Plug and Abandonment Procedure (Ver 2)

DJR Operating, LLC
Duff Federal Com #2
API # 30-039-05278

Re: Permanent Abandonment Well: Duff Federal Com #2

CONDITIONS OF APPROVAL

Proposed Wellbore P&A Diagram DJR Operating, LLC

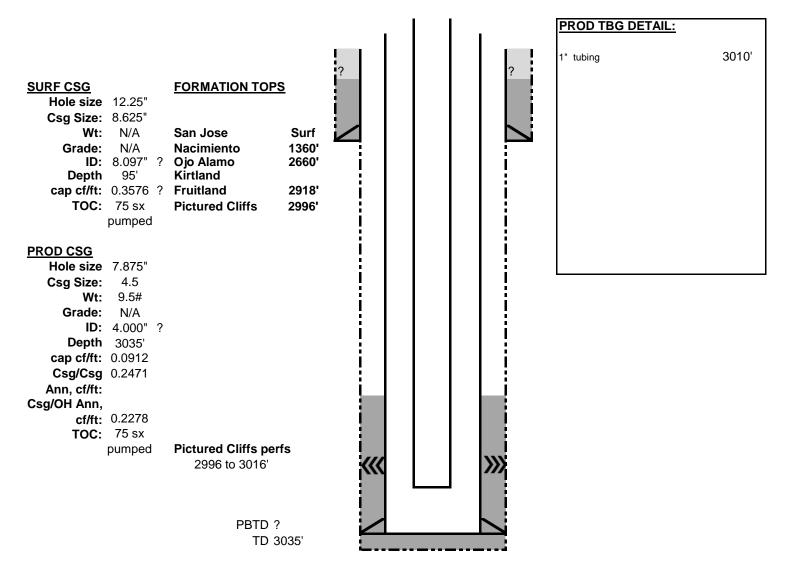
- Please ensure that the tops of the Pictured Cliffs and Fruitland formations as well as the entire Ojo Alamo aquifer, identified in this report, are isolated by proper placement of cement plugs. This will protect the freshwater sands in this well bore.

- 1. Plugging operations authorized are subject to the attached "General Requirements for Permanent Abandonment of Wells on Federal and Indian Lease."
- 2. Farmington Office is to be notified at least 24 hours before the plugging operations commence (505) 564-7750.
- 3. BLM picks top of Fruitland at 2880' md. TOC for plug 2 must be at least 2830' md.
- 4. BLM picks top of Ojo Alamo at 2630' md. TOC for plug 3 must be at least 2580' md.
